March 23, 2020

TFM Project No: 47361.00

**Re: Response to Comments from the January TAC Review for Condominium Development, Banfield Road, Tax Map 256, Lot 2**

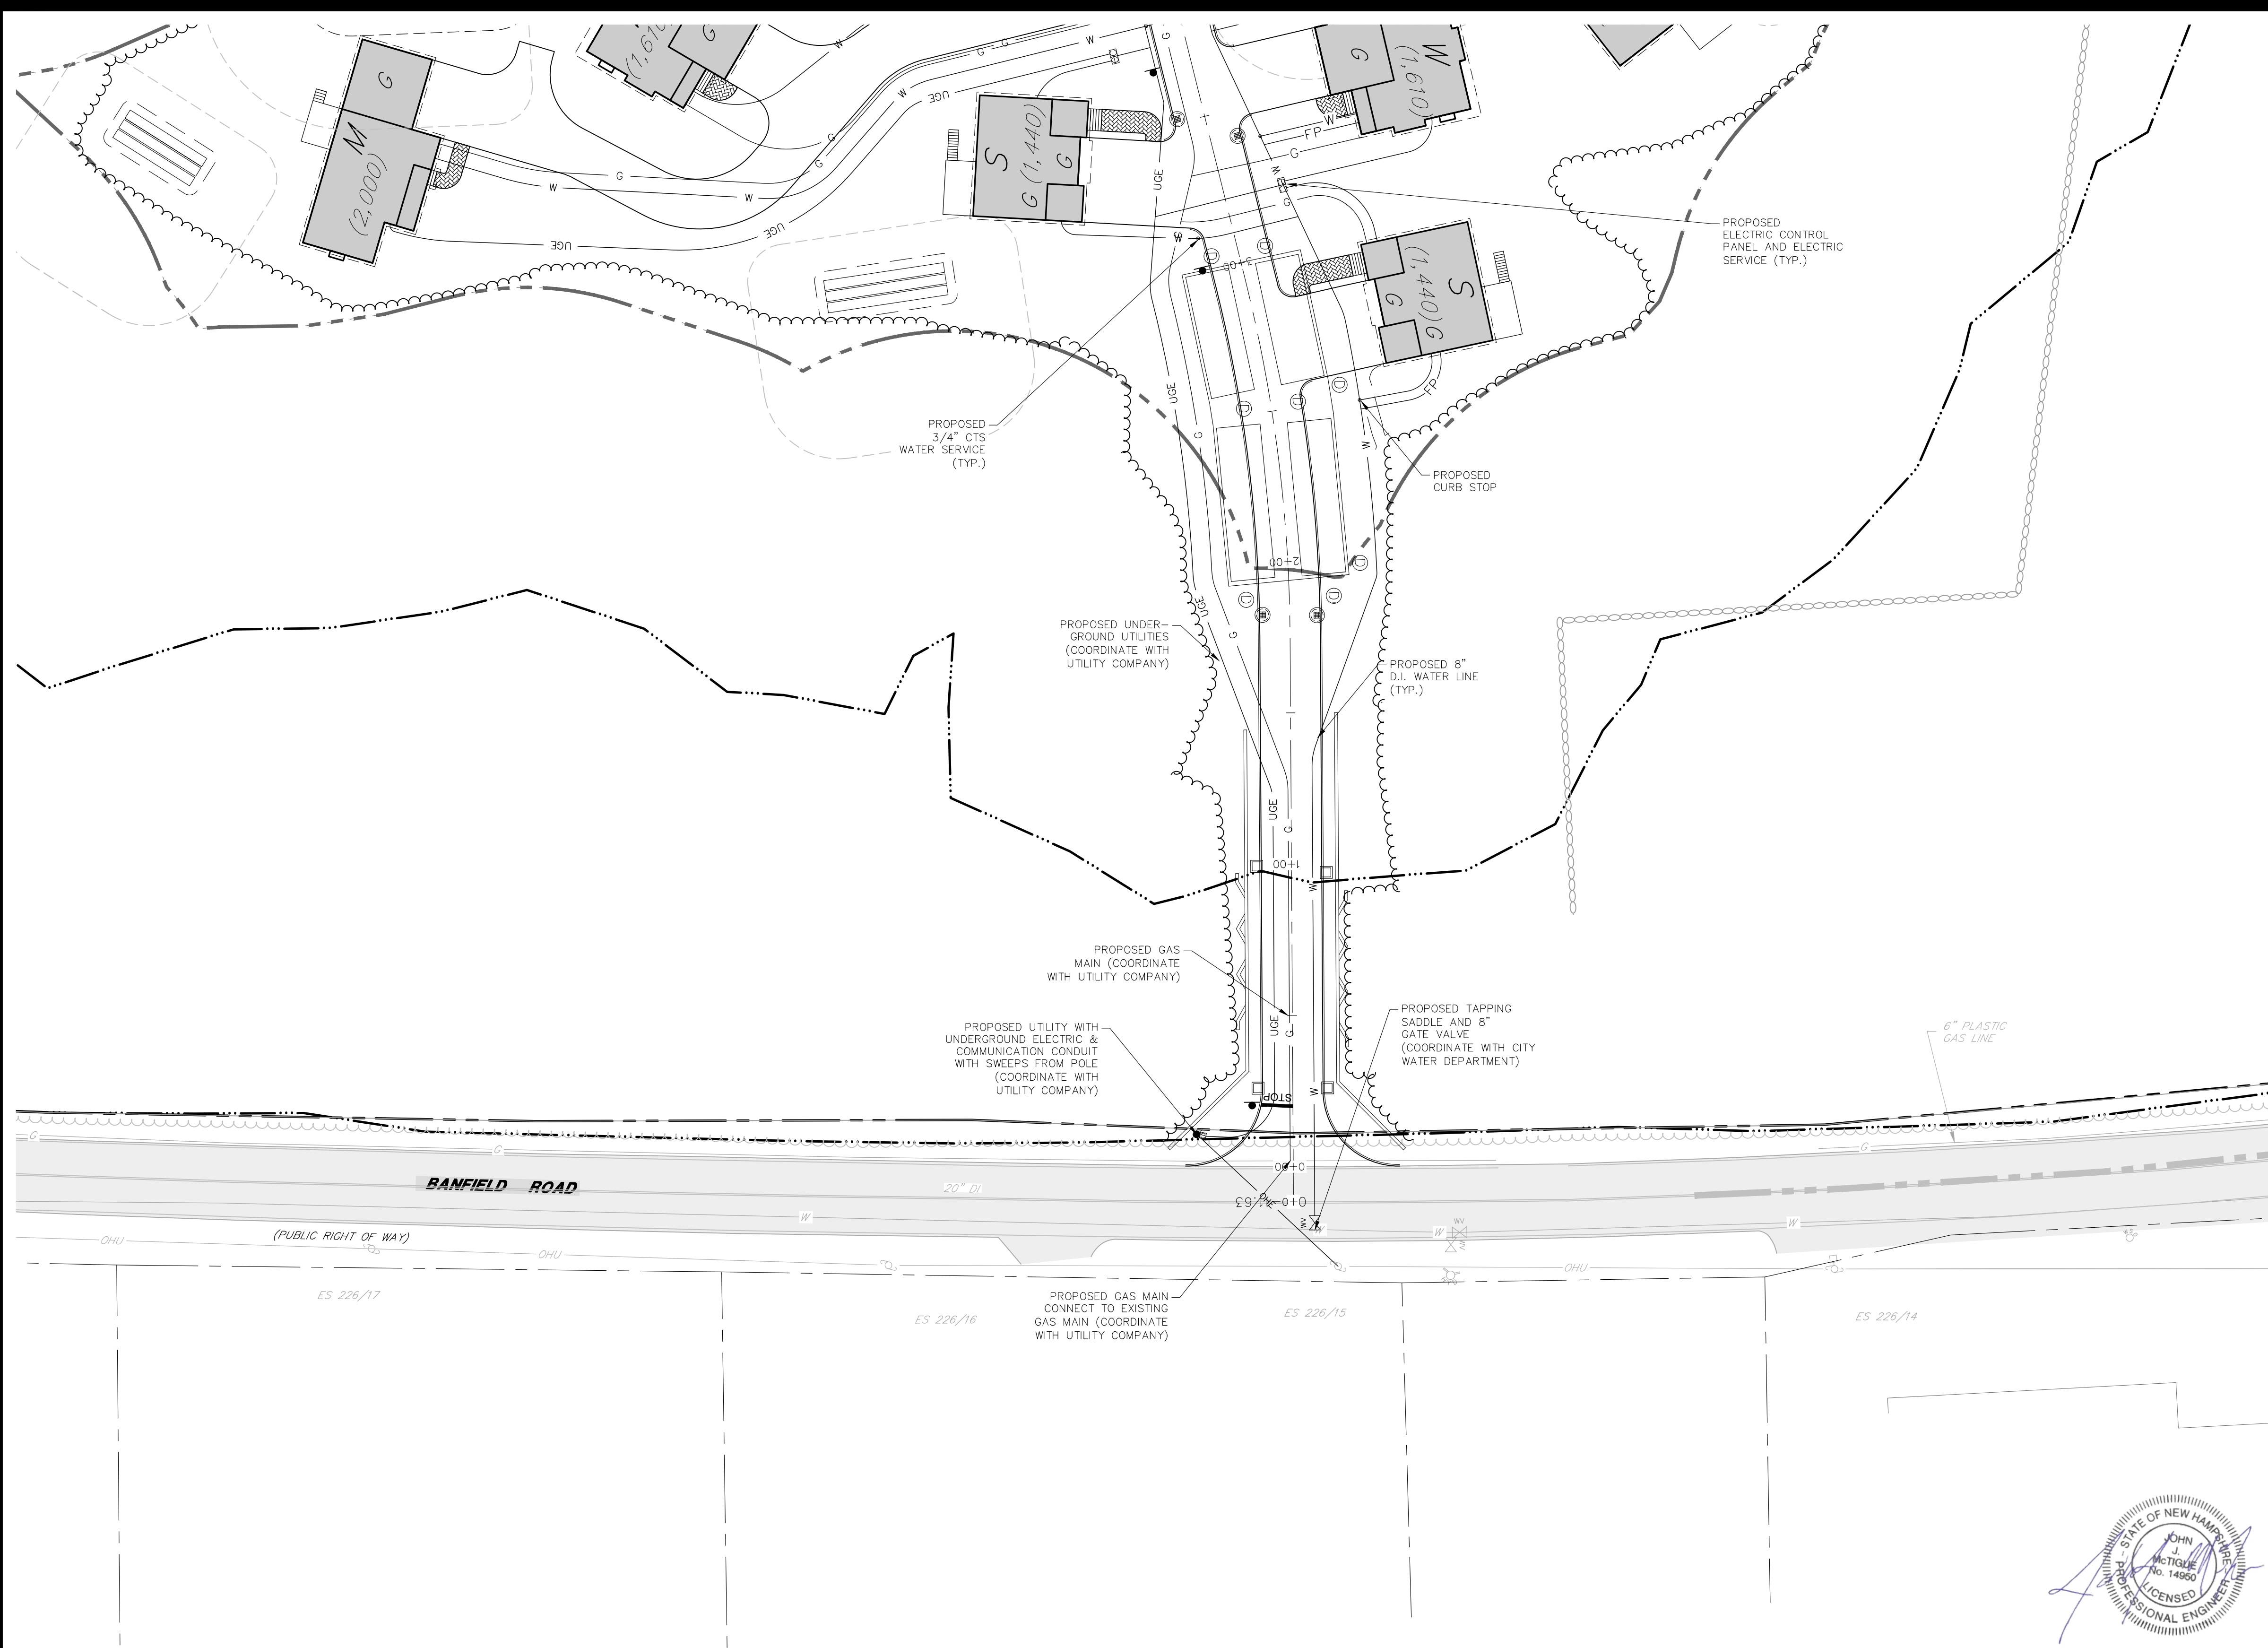
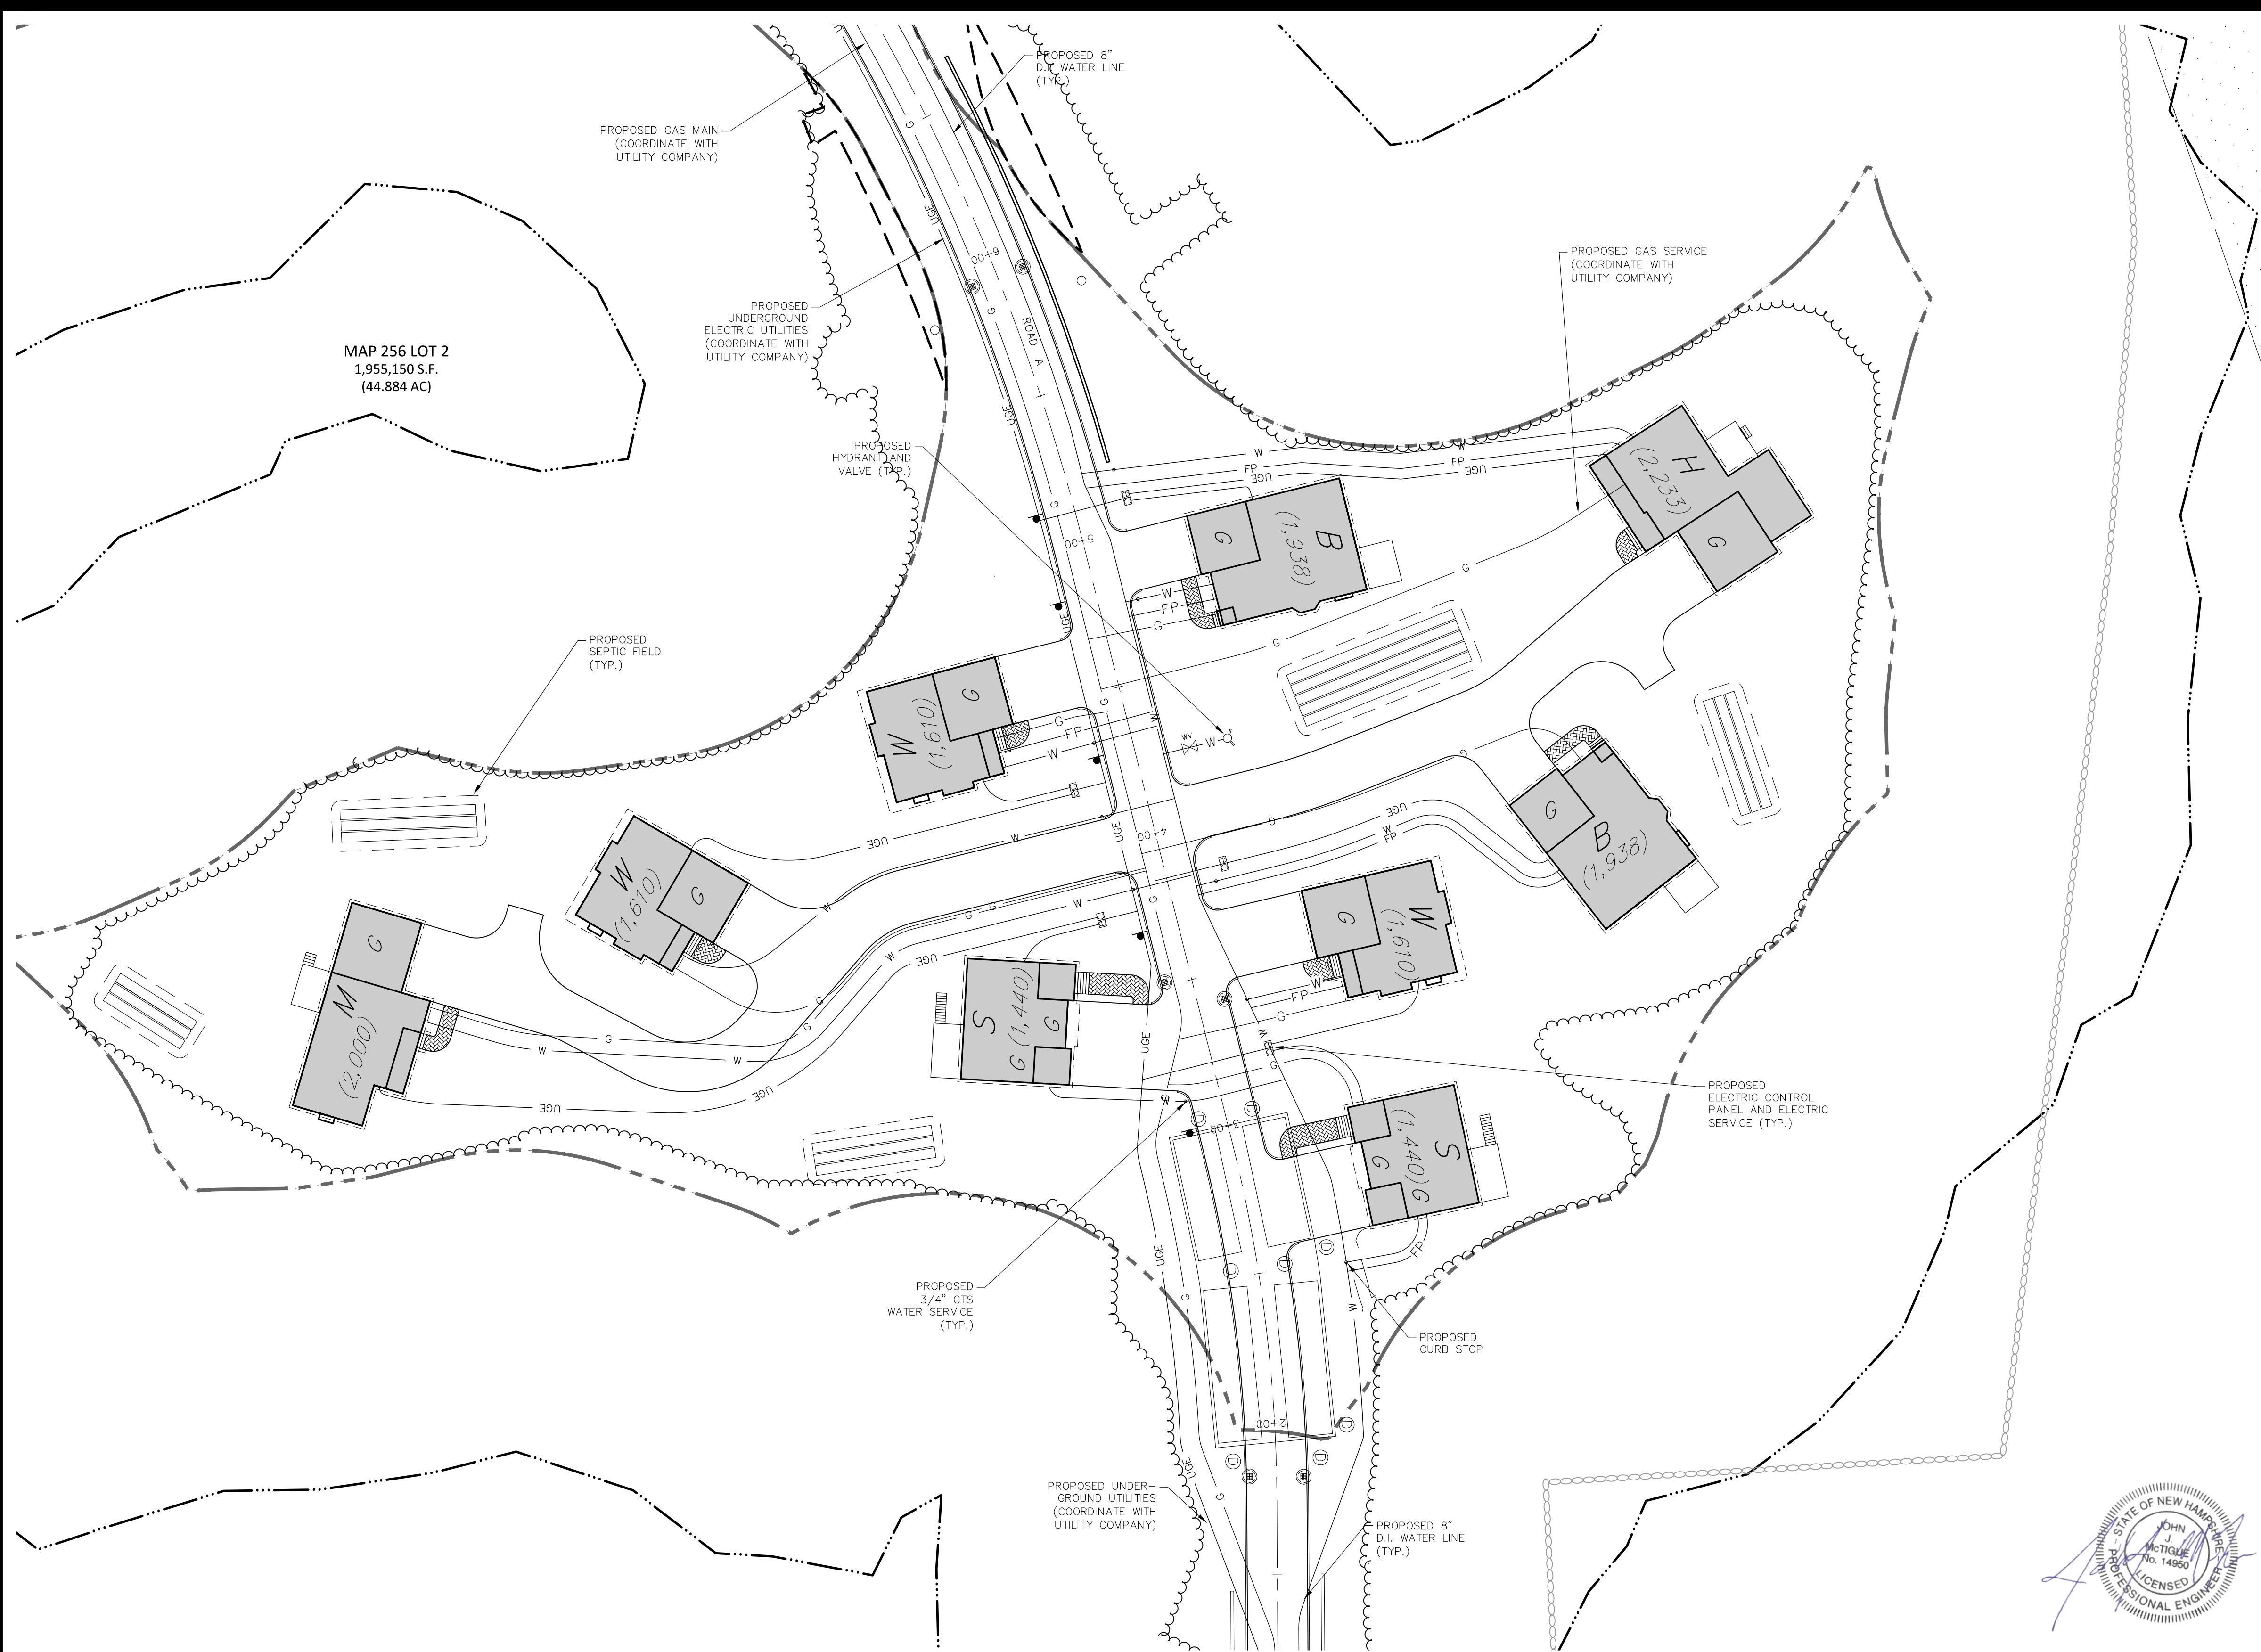
2. The utility plans are not showing water lines for fire suppression.  
*Response: Additional water services are shown for fire suppression. (See Sheets C-12 through C-15.)*

**ECO PASSAGE #1 DETAIL**  
NOT TO SCALE

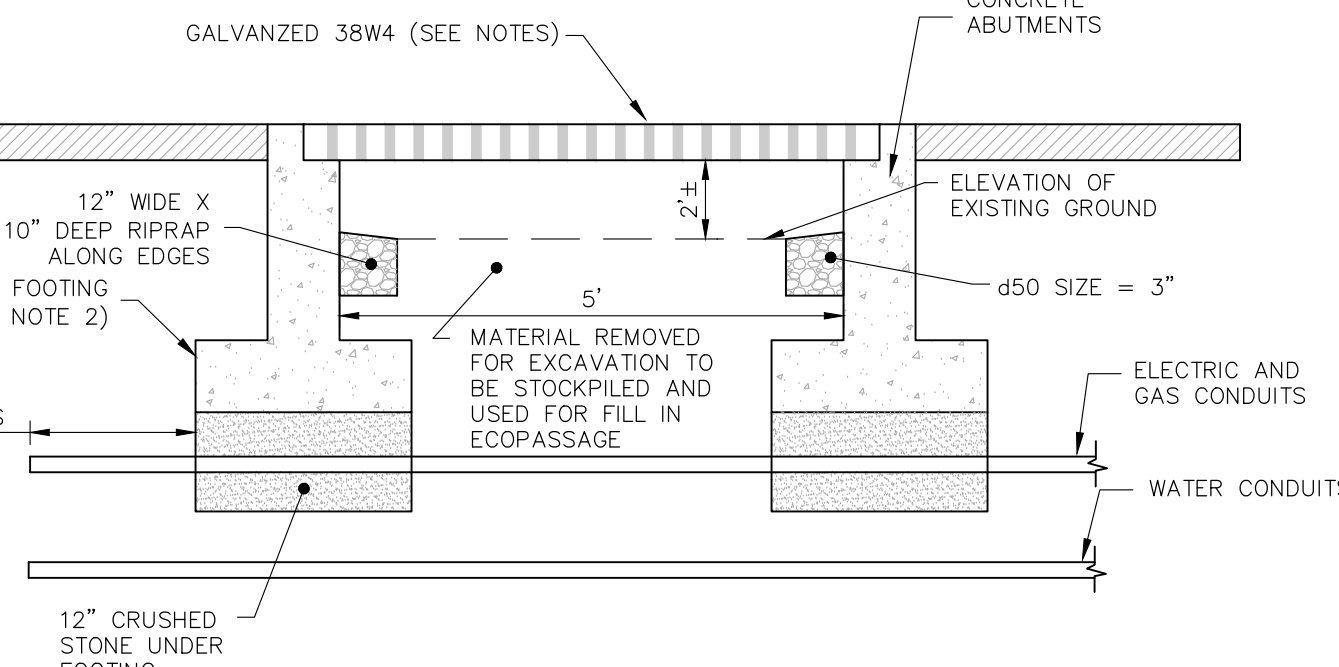
16. The applicant's plan of three individual crossings seems flawed and overly complex. A small bridge meeting current codes or other another design that is more appropriate and located a little farther from Banfield Road should be considered.

*Response: A bridge is not an option as adequate elevation over the wetland does not exist. After discussion with DPW, the requirement of 2% for 20' was reduced allowing us to relocated the ecopassages to increase the height of the tunnels. Two ecopassages are slightly over 24 inches in height, as recommended in the ecopassage documents, and one is 23 inches in height.*
